CITY OF ALBUQUERQUE

RE: **Lot 28 Block 5 Volcano Cliffs Unit 5 SAD 227
8024 Victoria Dr. NW.
Grading and Drainage Plan
Engineers Stamp Date 2/10/2023 (E10D123)**

BARGAS, MARTIN - G & D PLAN

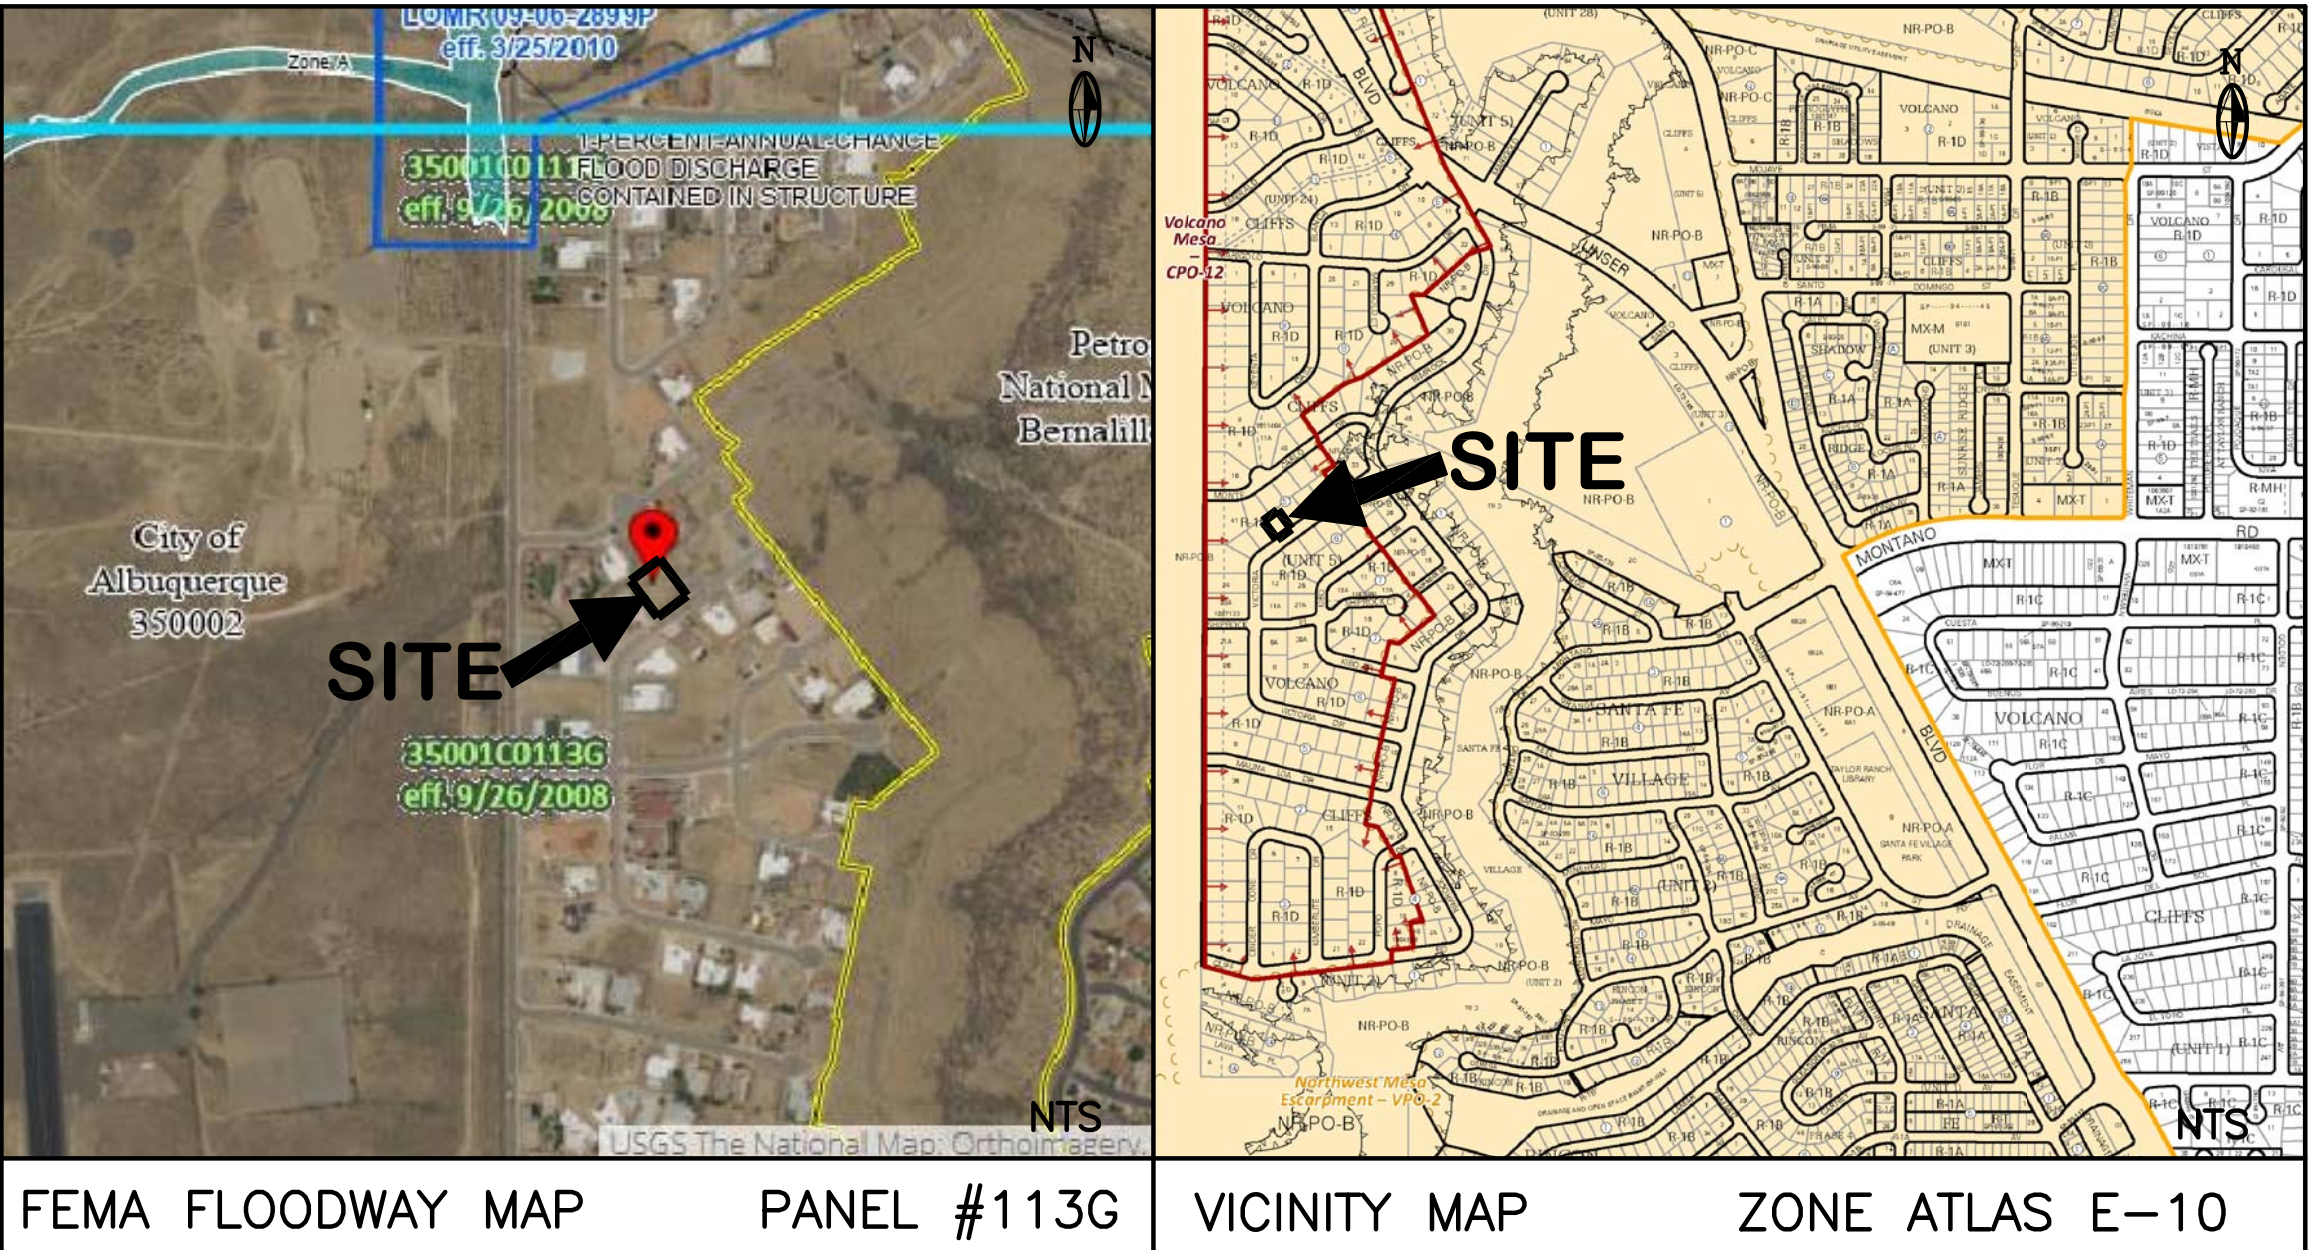
Based upon the information provided in your submittal received 2/27/2023, this plan is approved for Grading Permit.

Prior to Building permit approval a Pad Certification will be required, provided by the Engineer or a registered Land Surveyor.

Reiterate to the Owner/Contractor that a separate permit for a garden/retaining wall must be obtained, with the approved G&D plan, also inform the owner/contractor that dirt is not allowed to be used as a ramp to climb the curb, only crusher fines or lumber may be used for this process.

Prior to Certificate of Occupancy release, Engineer Certification per the DPM checklist of this plan will be required.
